SUBJECT: **RFQ FOR DESIGN-BUILD SVCS FOR VERTICAL/ARCHITECTURAL PROJECTS**

SUBJECT: CDB-0007-16 – Design-Build Services –Vertical/Architectural Projects – 911 Backup Call Center AMENDMENT 5C

AULD WHITE CONSTRUCTORS, LLC
911 BACKUP CALL CENTER PROJECT
CONTRACT # 9182-03

CHANGE ORDER NO. 1

FLOOR PLAN
SCALE 1/8" = 1'-0"

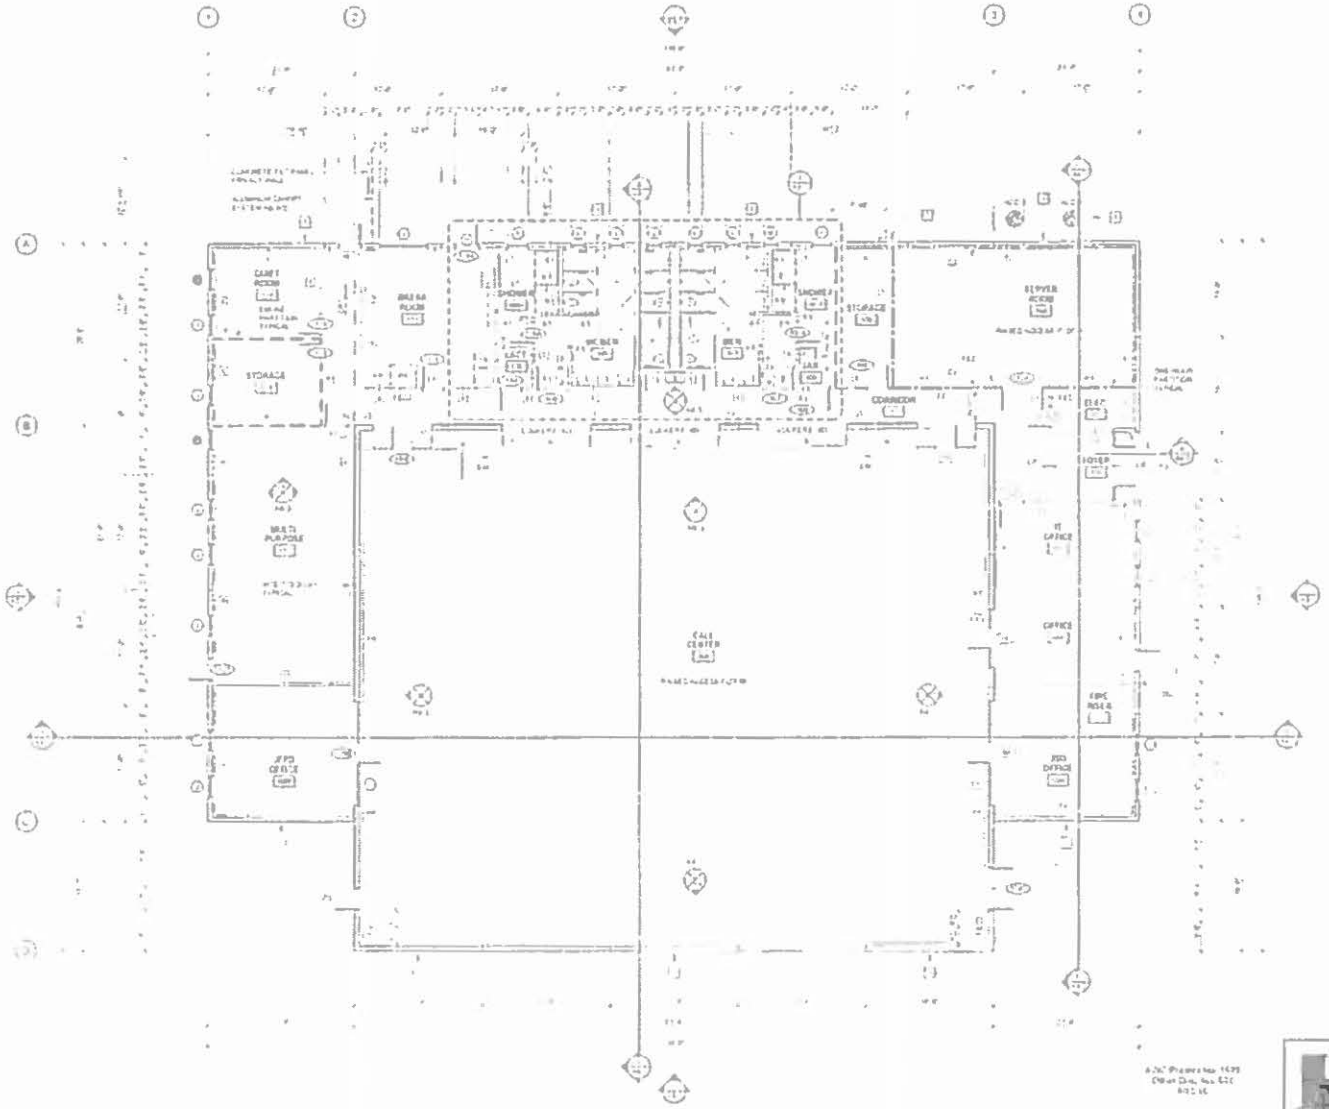
Furnish all labor, material and equipment necessary to properly complete the Drywall Assemblies, Door Hardware and 3'-0"x 7'-0" Wood Doors for the two (2) added Call Center Closets. Shelving, Wall Base, Carpet, Light Fixtures and Power Outlets have been excluded from the Proposal.
